**LR26**  
**Transport Assessment Addendum**  
Stantec

Project Name: Lots Road – Application Amendments  
Project No: 332610262  
Note No: TN001  
Date: 18 September 2025  
Prepared By: Jemima Odom/Paul Froggatt  
Subject: **Transport Assessment Addendum**

CAR PARK LAYOUT  
VEHICLE SWEEP PATH ANALYSIS FOR A  
STANDARD CAR

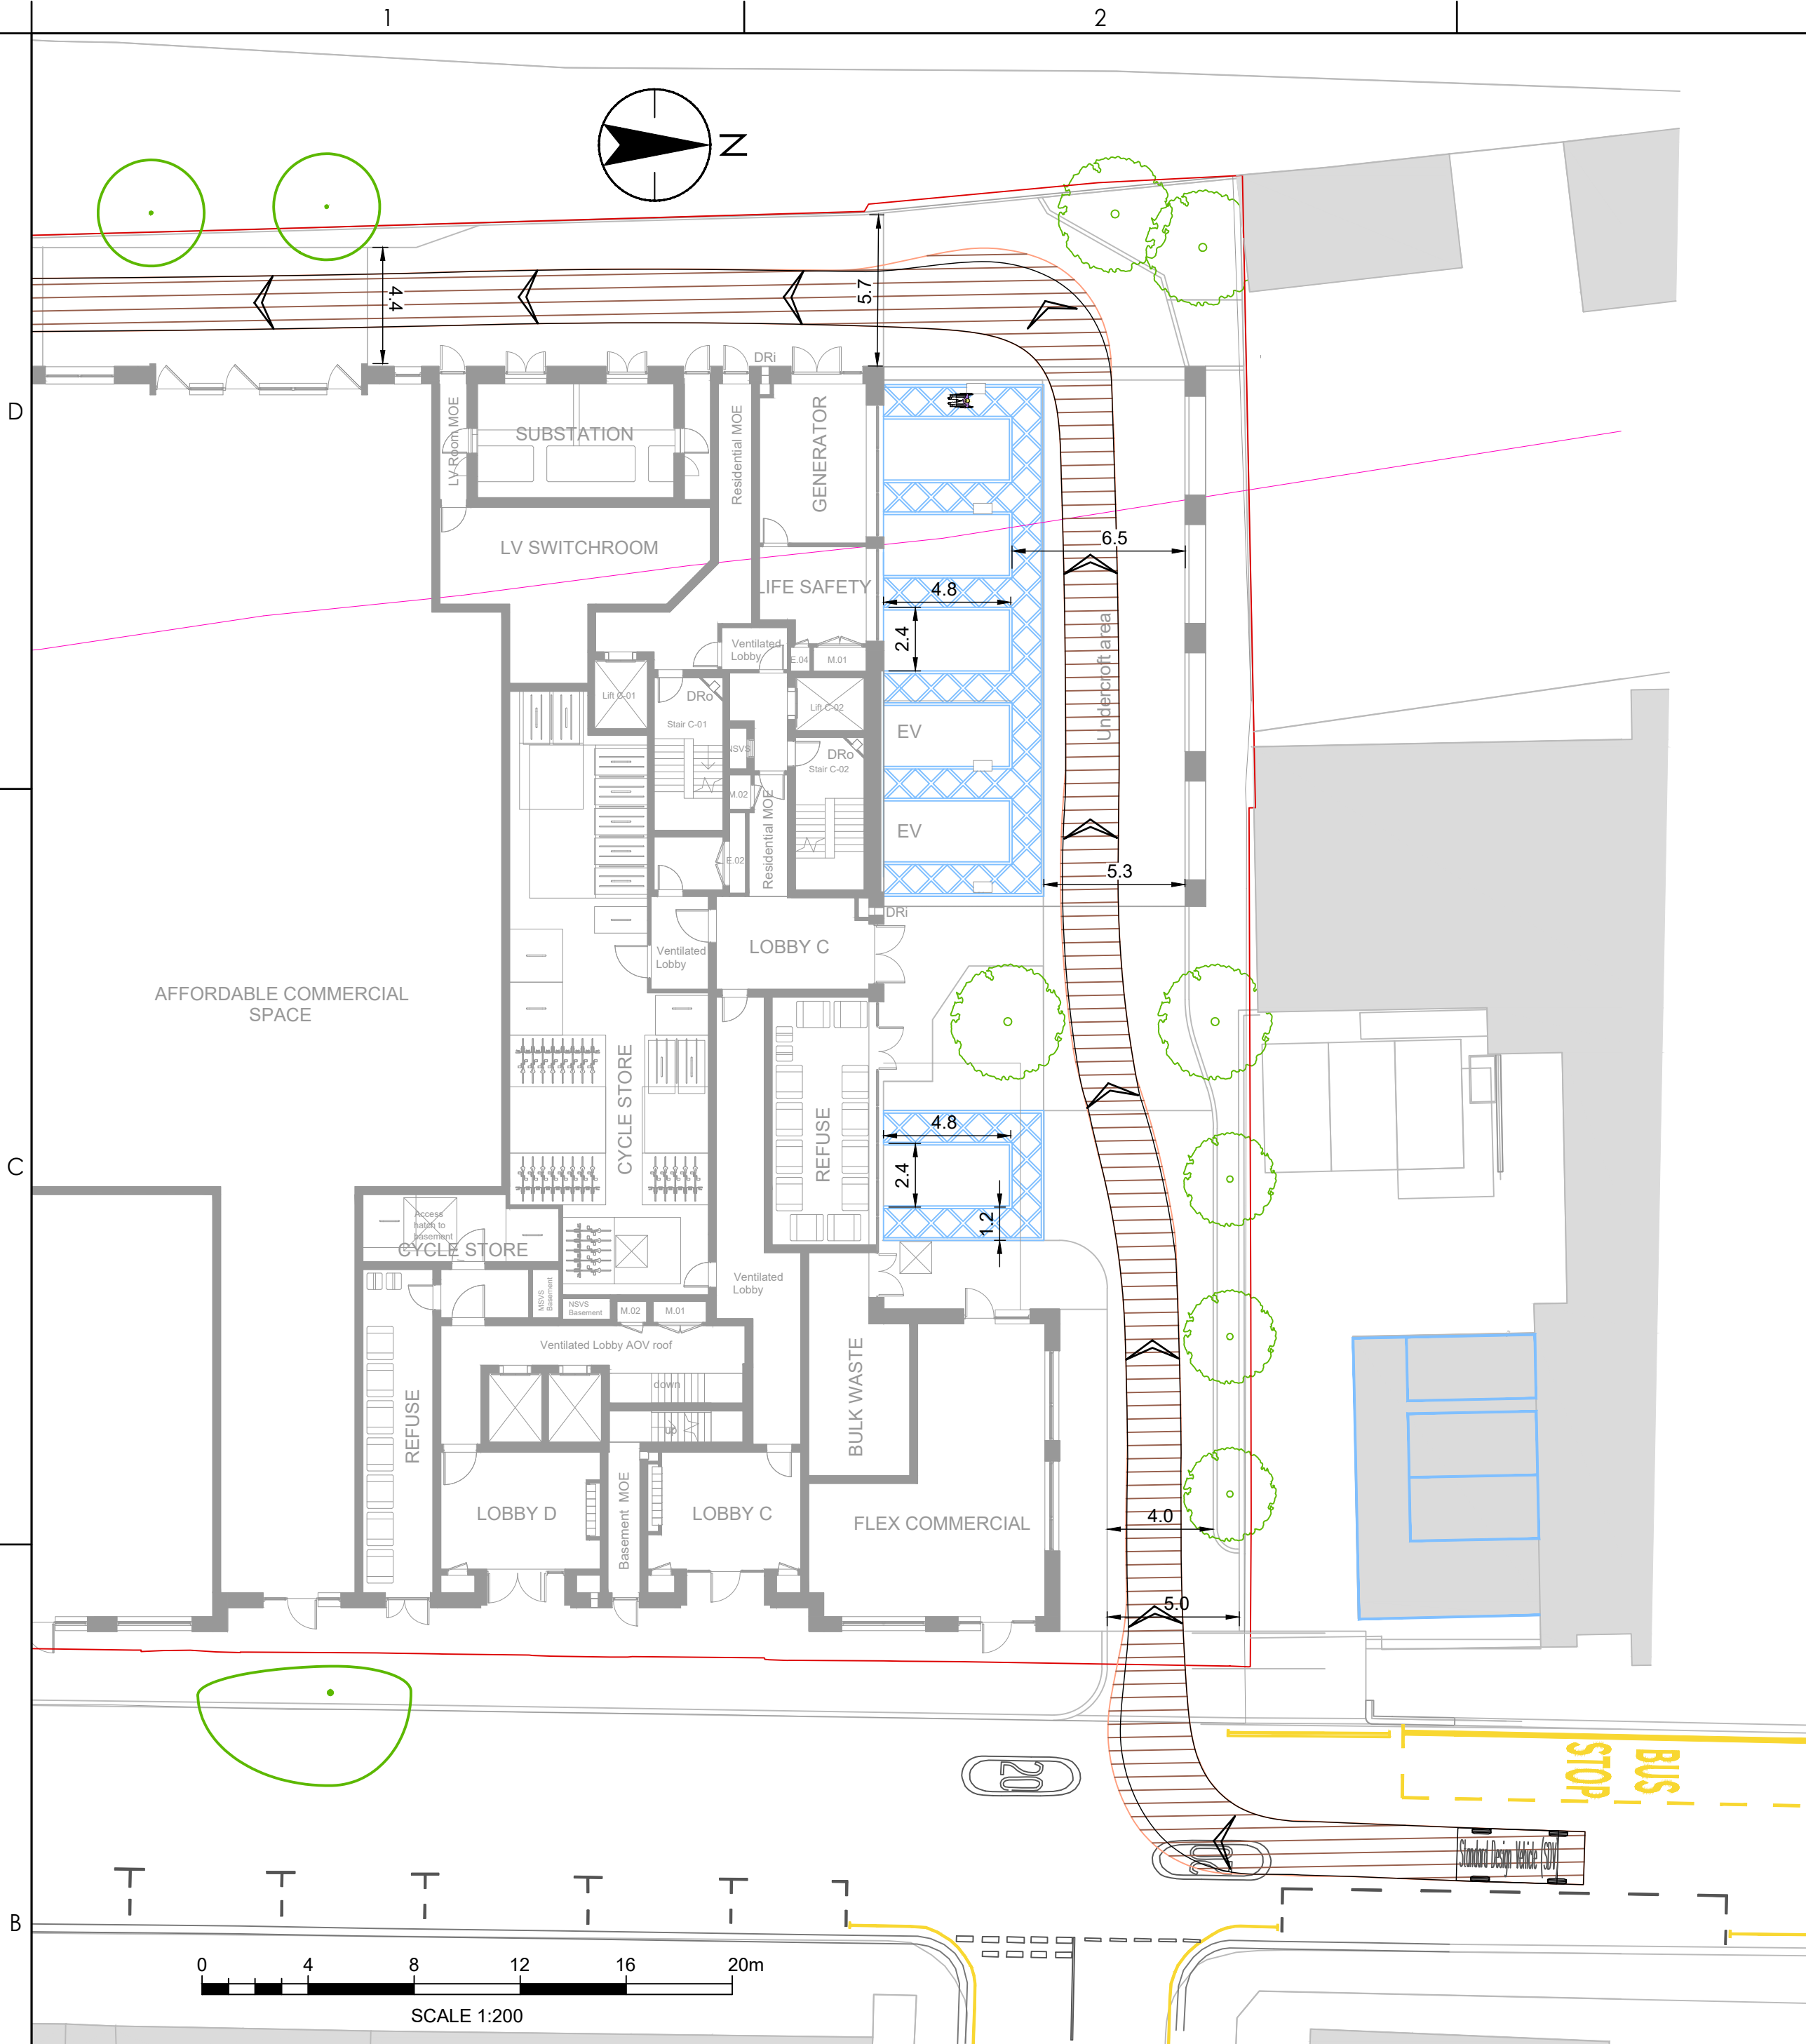
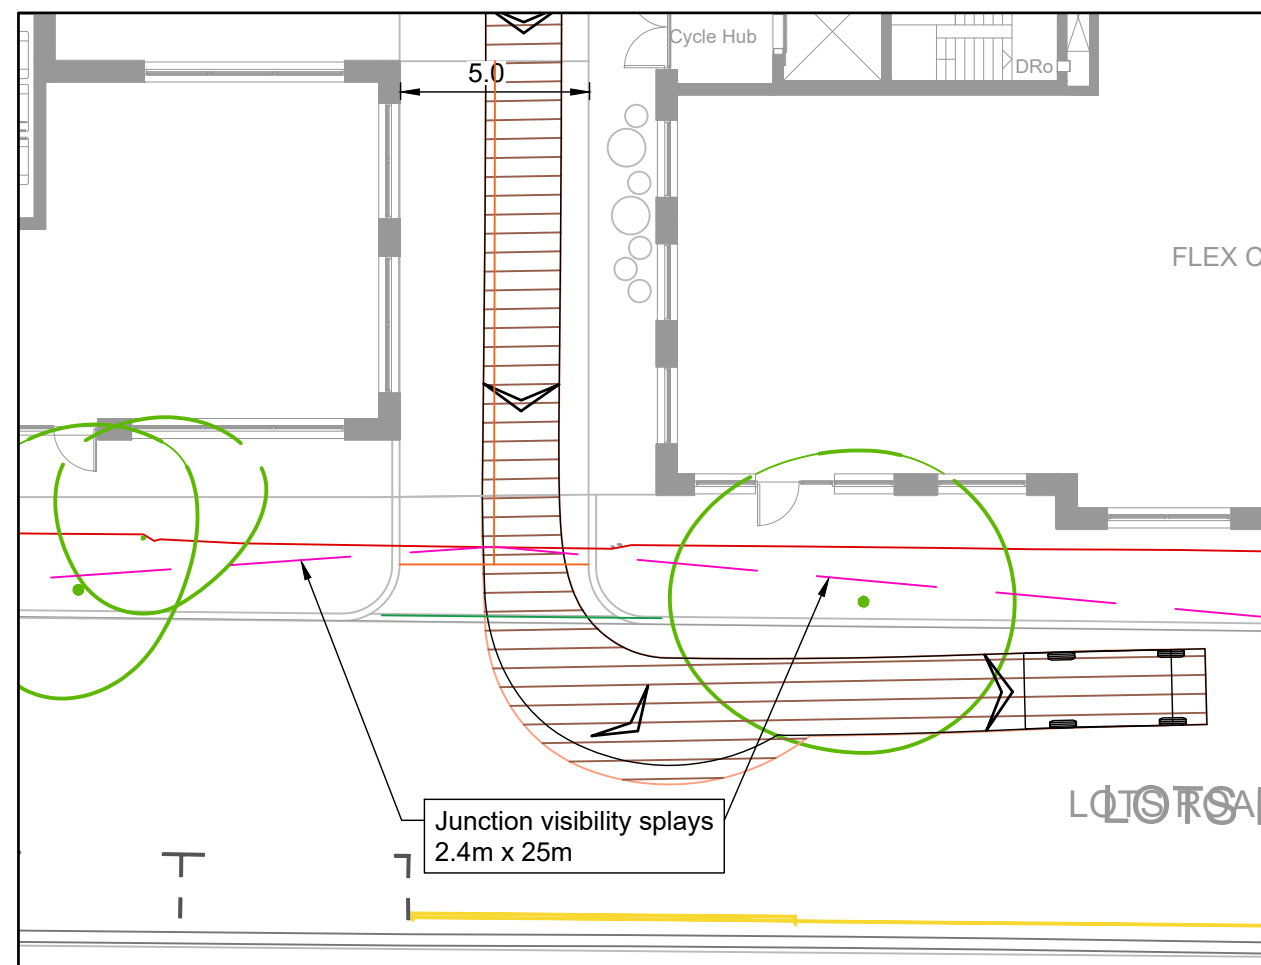
3.1 In the Original Submission, all vehicles except those belonging to Blue Badge holders were directed to enter via the northeastern access and exit between Blocks E and D. Blue Badge vehicles were proposed to use the northeastern access for both entry and exit. This arrangement has now been revised so that the six Blue Badge vehicles will follow the same internal route as the other vehicles permitted on site. This eliminates the potential for vehicular access/egress conflict.

3.2 Figure 7-2 of the submitted Transport Assessment identified 24 daily driver trips associated with the six Blue Badge parking spaces (12 trips to enter and 12 trips to exit the site, both at the north eastern access point). The only change is the routing of these blue badge vehicles

on exit. The 12 trips to exit will now be via the internal loop route, exiting between Blocks D and E.

- 3.3 This change will have no impact on the external transport network. The number of vehicle trips generated by the site and those accessing Lots Road remains the same as previously assessed. Therefore, the overall transport impact remains unchanged from that outlined in the Transport Assessment. The minor increase in trips along the western side of the site and through the public realm area is not anticipated to impact on the amenity and safety of this area for other users.

SITE LAYOUT  
VEHICLE SWEEP PATH ANALYSIS FOR A  
REFUSE COLLECTION TRUCK

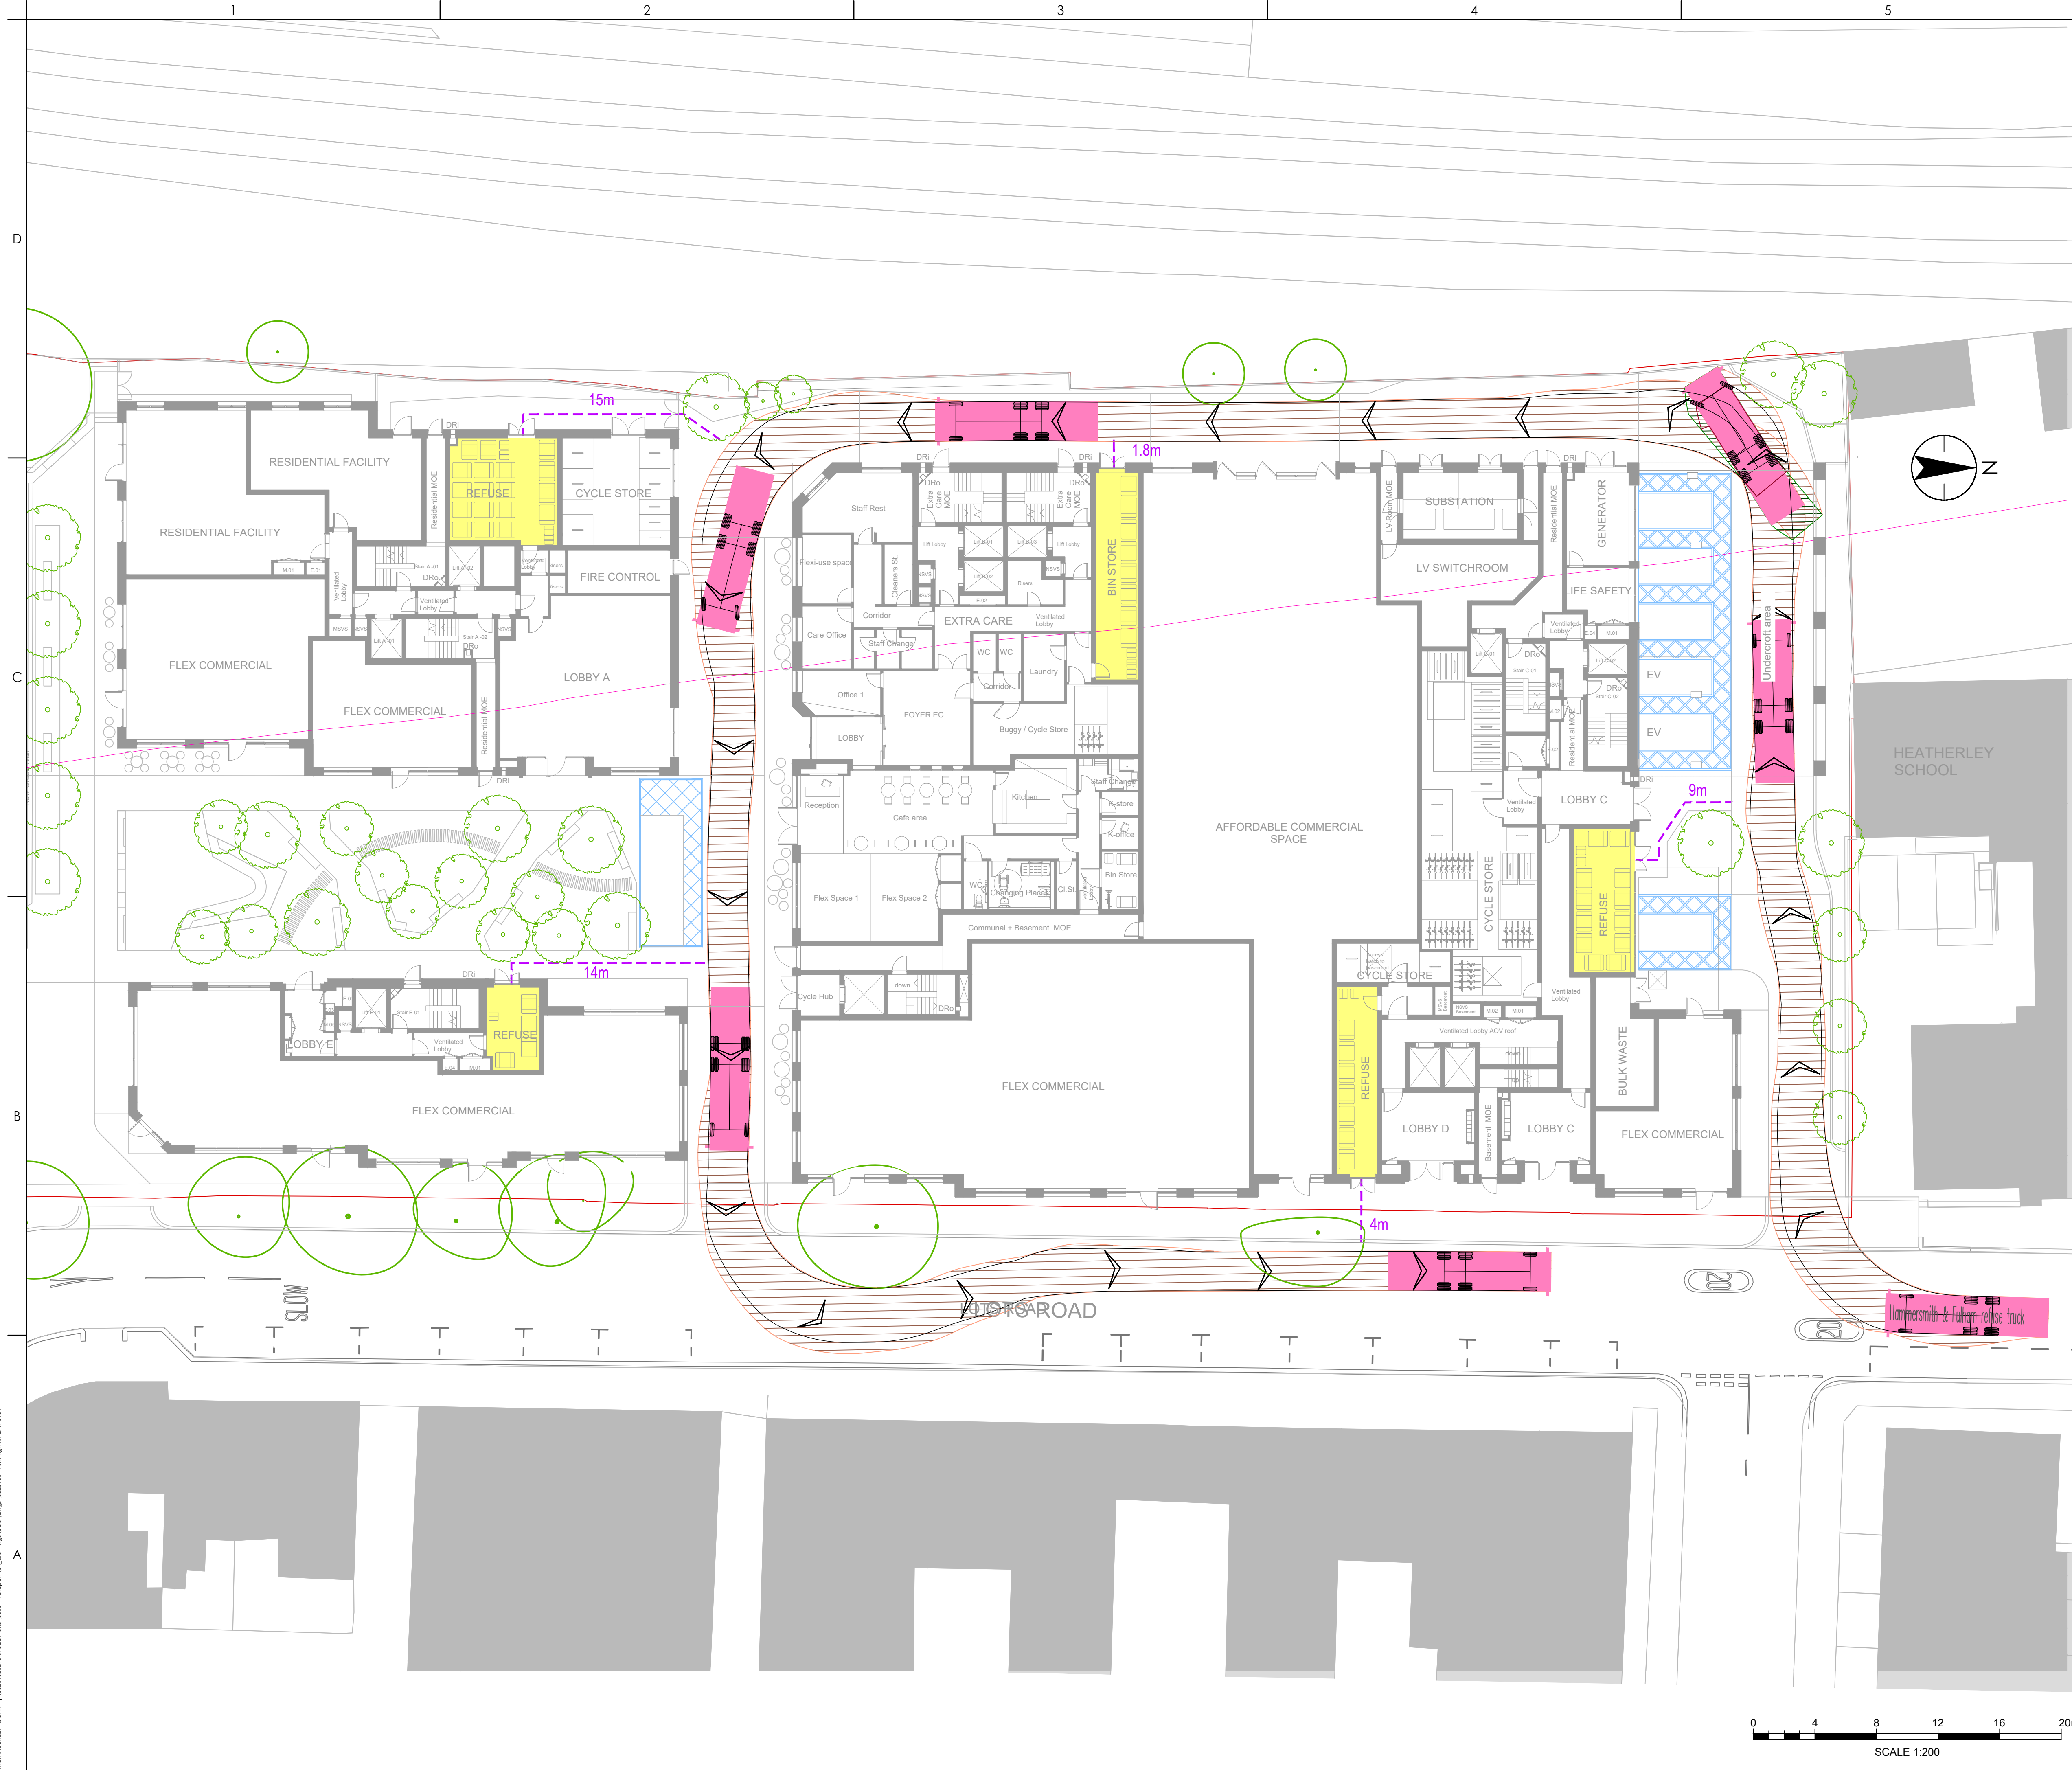
As part of the overall amendments to the site plans, there have been minor changes to the internal layouts and building frontages. This includes changes to the location of the waste

stores for Block D. Swept paths for all vehicles anticipated to enter and/or circulate through the site have therefore been prepared and are appended to this addendum. The swept paths comprise the following vehicles and drawings.
